Comments to the SAB on 8-29-18 Draft Quality Review of EPA's Biogenic C Accounting Framework

Mary S. Booth, PhD
Partnership for Policy Integrity

Shaye Wolf, PhD
Center for Biological Diversity

September 19, 2018

Figure 1a. It doesn't matter if you compute the difference between the bioenergy and counterfactual scenarios for the whole "landscape," or just those plots that are affected by biomass harvesting – the difference in carbon stocks is the same.

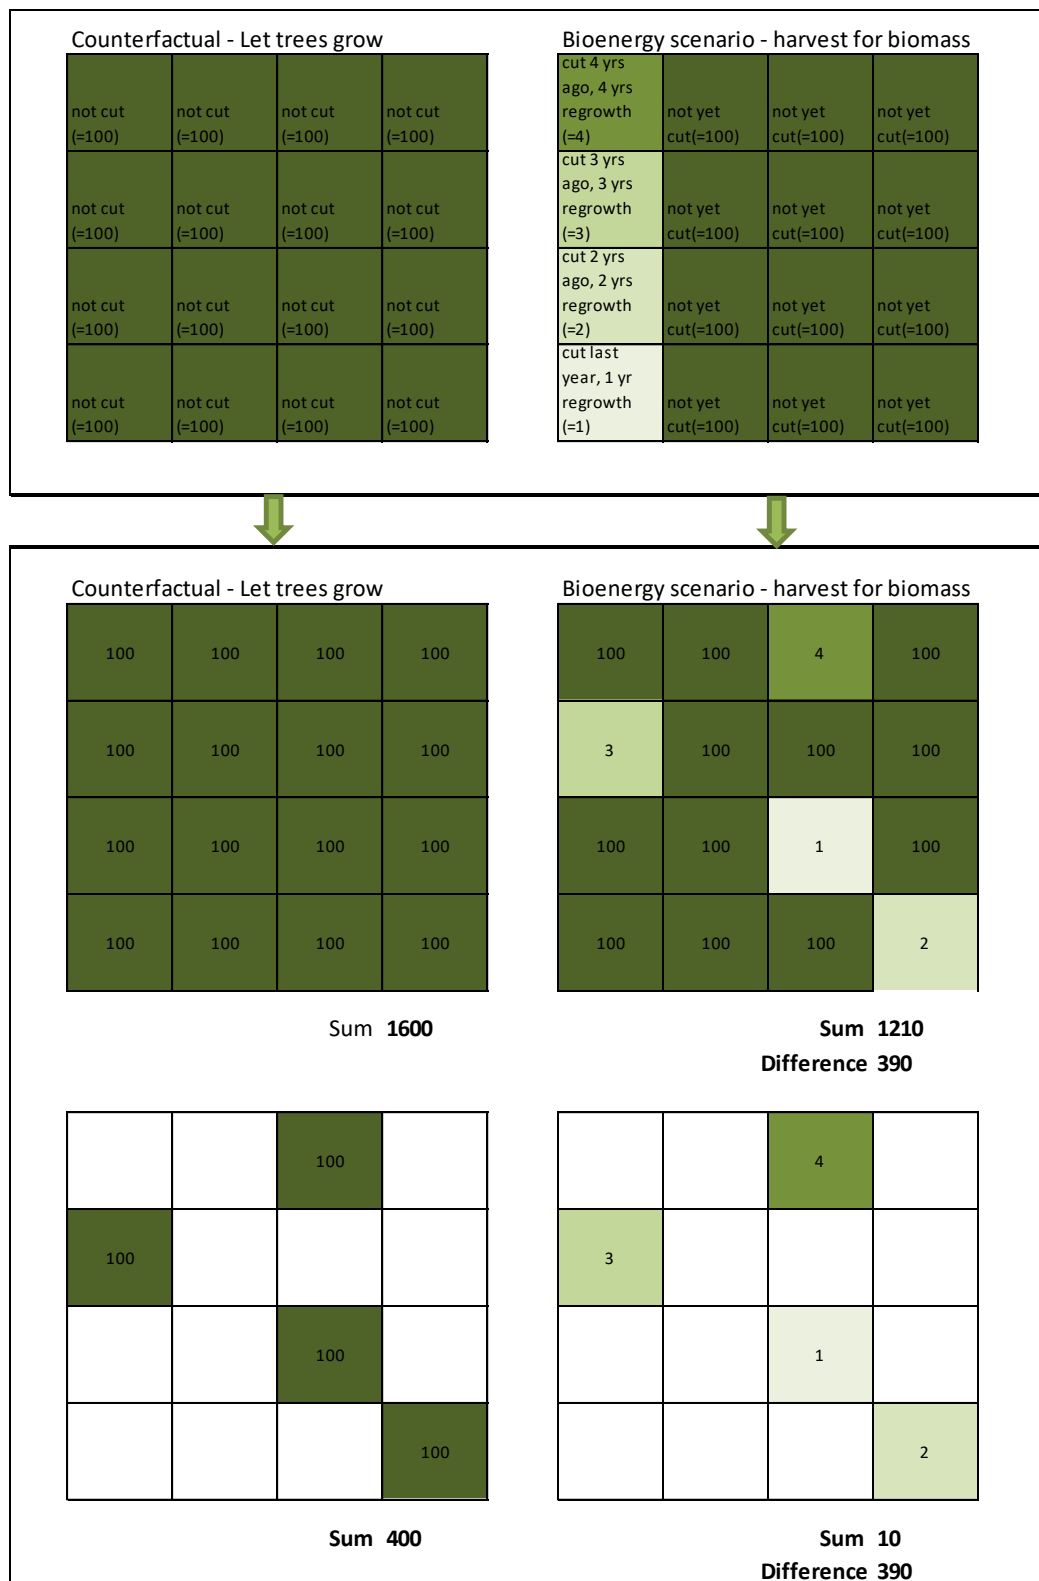
In fact, as Figure 1 demonstrates below, a landscape level analysis done correctly should produce the same result as a stand-level analysis.

The scenarios in Figure 1 conceive of the landscape as an assemblage of plots. In this simple example, the goal is to generate a BAF for biomass sourced from cutting trees. Trees are cut for fuel in the biomass scenario, and trees continue growing in the counterfactual scenario. We want to know the cumulative difference in carbon stocks between the two scenarios, which informs the BAF. Each plot contains 100 tonnes of carbon. Each year a plot, or a set of plots, is cut for fuel, resetting aboveground stocks to zero. Plots then regrow, adding one tonne of carbon per year (actual regionally specific regrowth estimates can be obtained using forest programs such as the Forest Vegetation Simulator, which uses FIA data). This analysis calculates the difference in carbon stocks between the two scenarios at Year 4. This example demonstrates that it doesn't matter if you compare the whole landscape to its counterfactual, or just those plots that have been cut - the carbon impact, calculated as the difference between the scenarios, is the same.
